Permanent Fitzroy and Collingwood Design and Development Overlays

Design and Development Overlay Schedule 29 - Brunswick Street Shops

The below changes indicate general changes made to the adopted interim DDOs to form the recommended permanent DDOs.

Map 1: Building and Street Wall Heights (North of Greeves Street, Fitzroy)

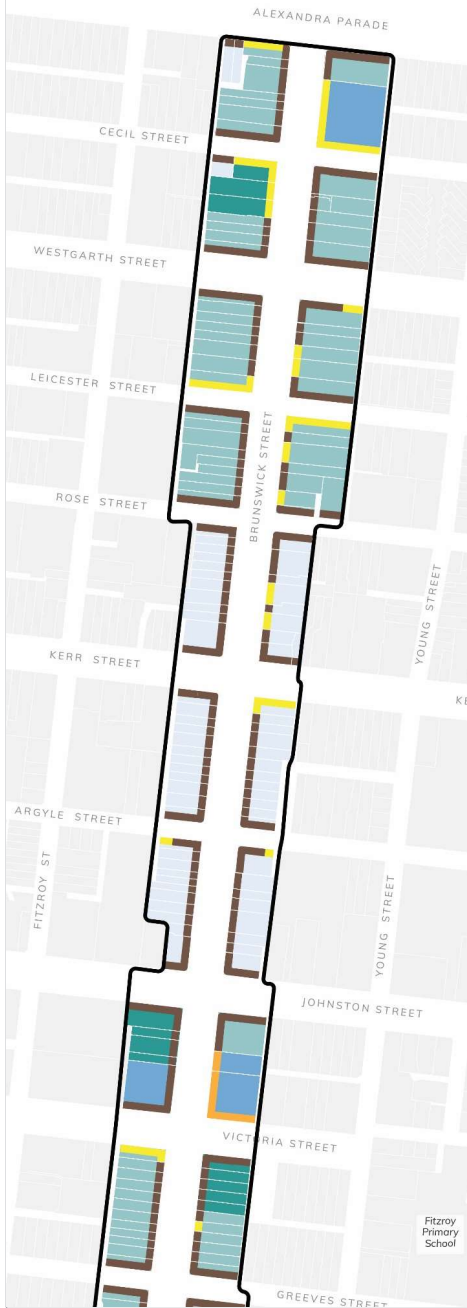
Commented [YCC13]: In response to feedback and heritage advice, building heights between Cecil Street and Leicester Street have been reduced to 4 storeys, except for non-contributory sites along the northern half of the block near the Cecil/Brunswick Street corner.

Commented [YCC12]: Amended map legend headings to clarify mandatory and preferred requirements where a mix of both is recommended. Responds to community feedback, including from other recent amendments.

Map 1: Building and Street Wall Heights

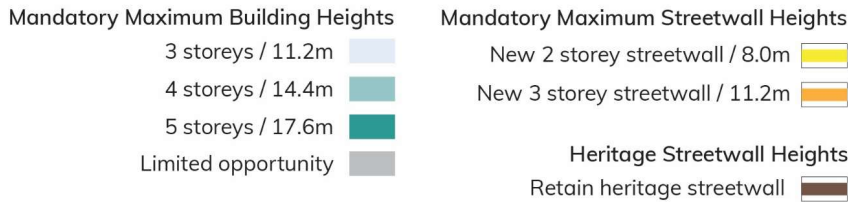
Commented [YCC65]: Amended map legend headings to clarify mandatory and preferred requirements where a mix of both is recommended. Responds to community feedback, including from other recent amendments.

Map 1: Building and Street Wall Heights (South of Hanover Street)

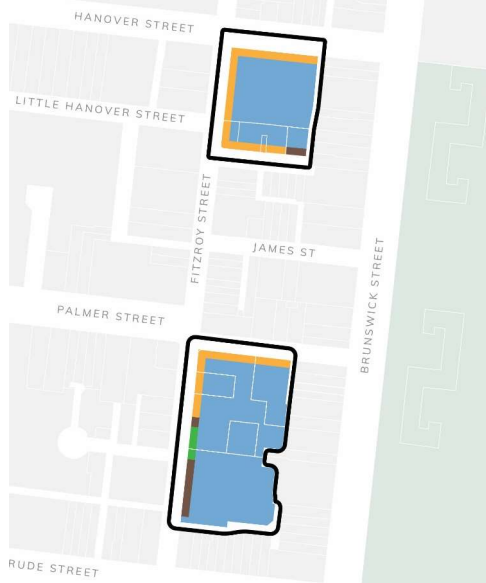
Commented [YCC139]: Amended map legend headings to clarify mandatory and preferred requirements where a mix of both is recommended. Responds to community feedback, including from other recent amendments.

Map 1: Building and Street Wall Heights

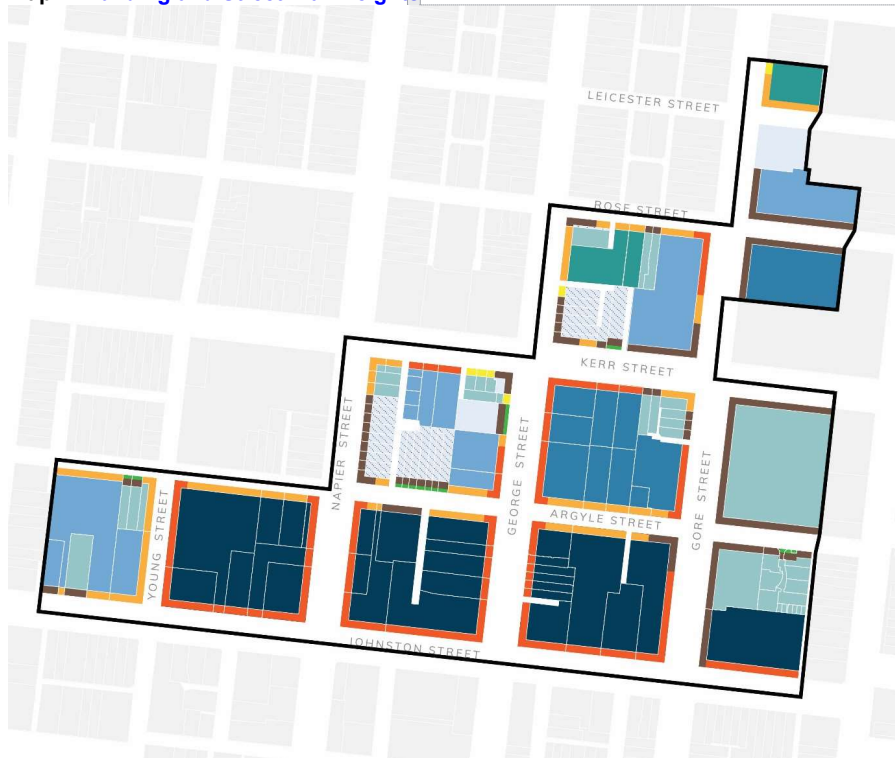
Commented [YCC194]: Amended map legend headings to clarify mandatory and preferred requirements where a mix of both is recommended. Responds to community feedback, including from other recent amendments.

Map 1: Building and Street Wall Heights (North of Kerr and Hotham Streets)

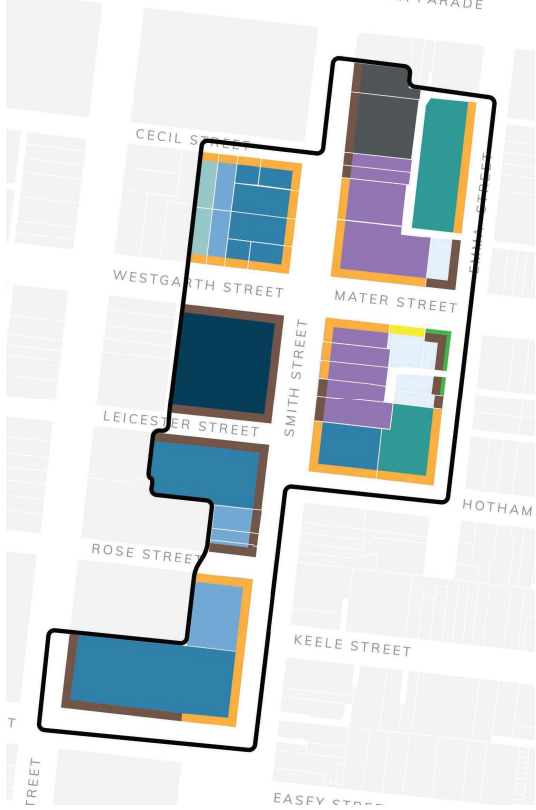
Commented [YCC219]: Amended map legend headings to clarify mandatory and preferred requirements where a mix of both is recommended. Responds to community feedback, including from other recent amendments.

Figure 1: Indicative Cross Section and Measurements

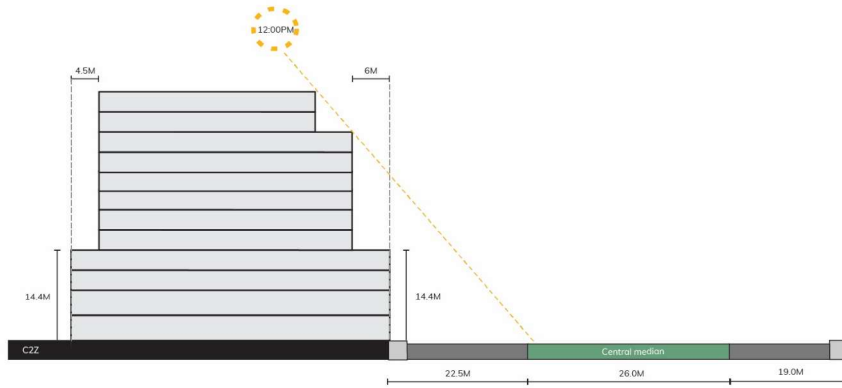
Commented [YCC278]: Submission requested clarification

Map 1: Building and Street Wall Heights

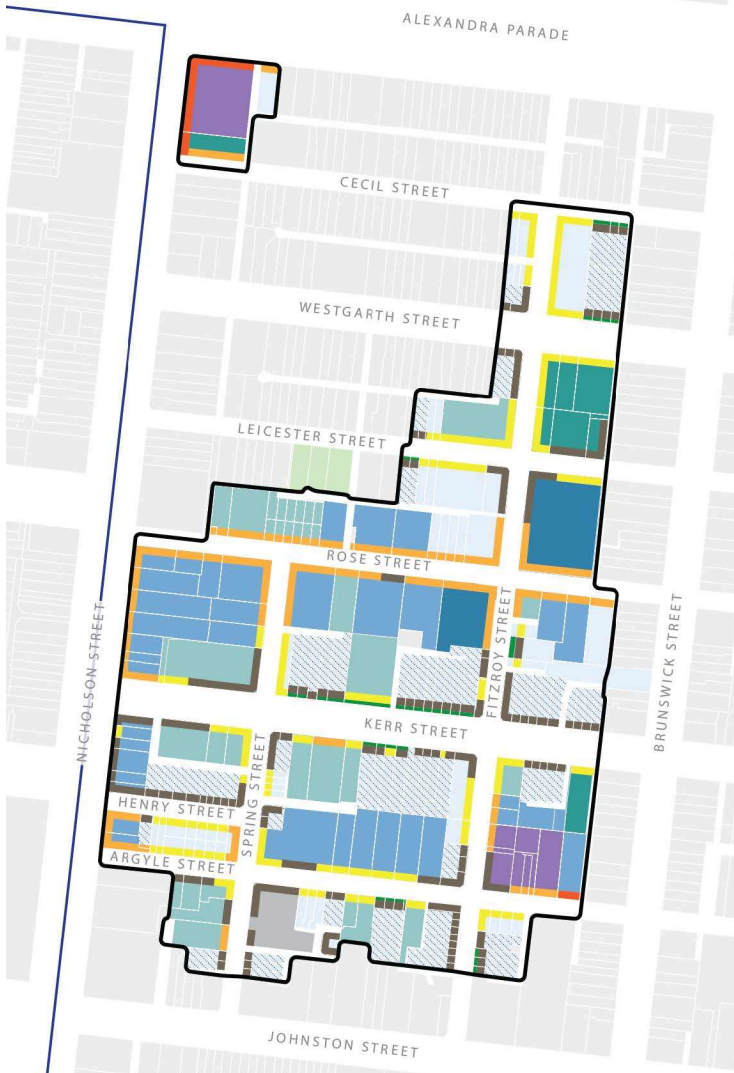
Commented [YCC306]: Amended map legend headings to clarify mandatory and preferred requirements where a mix of both is recommended. Responds to community feedback, including from other recent amendments. Please note that in DDOs29, 30 and 31 all building and street wall heights are recommended as mandatory.
